SUBJECT: AMENDMENT NO. 38 TO FACILITY OPERATING LICENSE NO. NPF-14,
SUSQUEHANNA STEAM ELECTRIC STATION, UNIT 1

AMENDMENT NO. 38 TO FACILITY OPERATING LICENSE NO. NPF-14 - SUSQUEHANNA STEAM
ELECTRIC STATION, UNIT 1

SAFETY EVALUATION

AMENDMENT NO. 38 TO NPF-14

BASES FIGURE B 3/4 3-1
REACTOR VESSEL WATER LEVEL

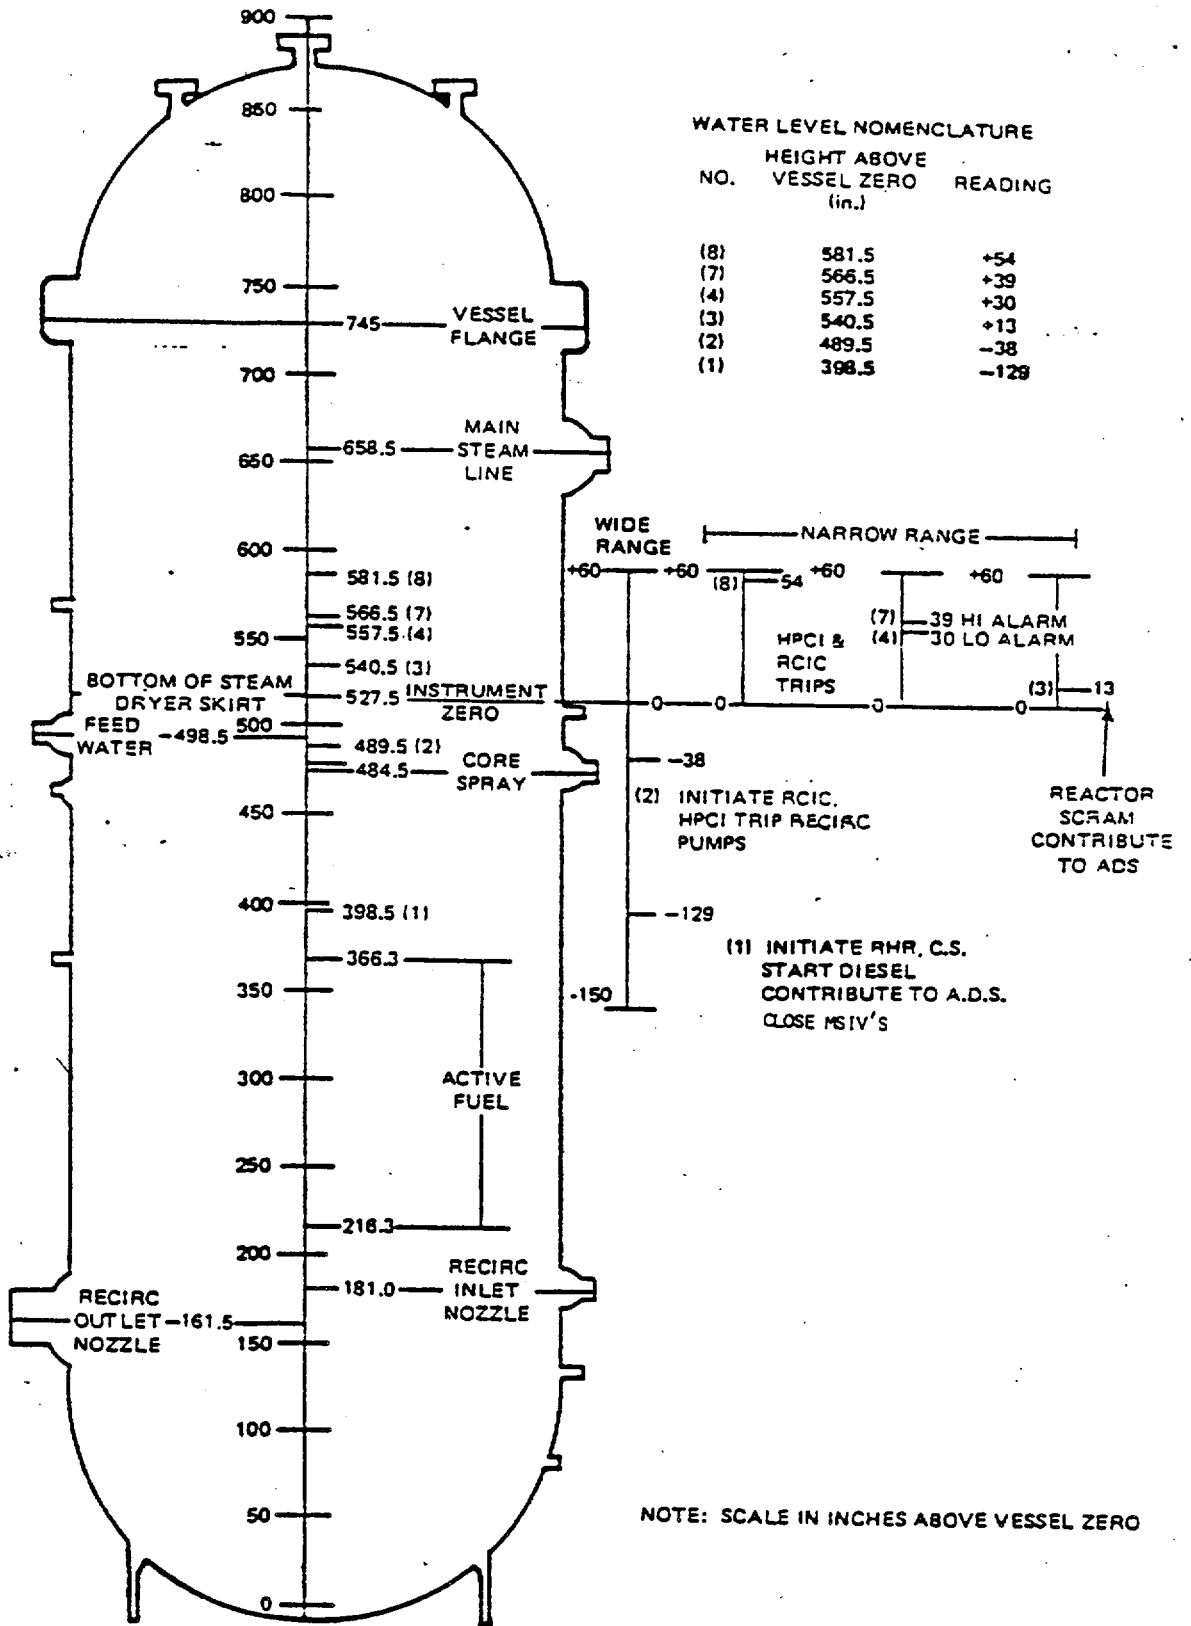
The Nuclear Regulatory Commission has issued the enclosed Amendment No. 38 to Facility Operating License No. NPF-14 for the Susquehanna Steam Electric Station, Unit 1. The amendment is in response to your letter dated October 31, 1984. This amendment revises the Technical Specifications to change the setpoint for main steam isolation valve (MSIV) closure on reactor vessel water low level from Level 2 to Level 1.

The licensee proposed changes to the Technical Specifications of the operating license for Susquehanna Steam Electric Station, Unit 1 to lower the setpoint for main steam isolation valve (MSIV) closure from low water level 2 (Level 2) to low water level 1 (Level 1).
